Now! An Even Greater **RCA-807**

HIGHER RATINGS IMPROVED PERFORMANCE MORE OUTPUT

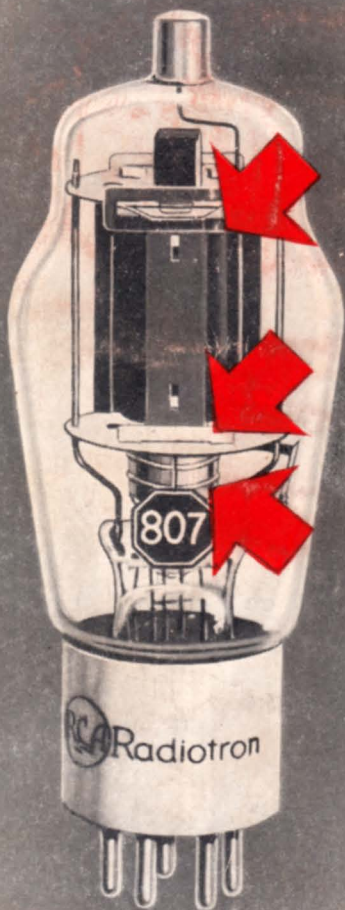
The maximum rated plate voltage is now increased to 600 volts for Class C telegraph service. This higher rating, made possible by a new electrode structure using ceramic insulation to isolate the plate, provides for a 50% greater input and an increasingly larger output

New shielding gives greater stability and further lessens need for neutralization in those borderline cases. With the new 807, it is easier to avoid parasitics and self-oscillation.
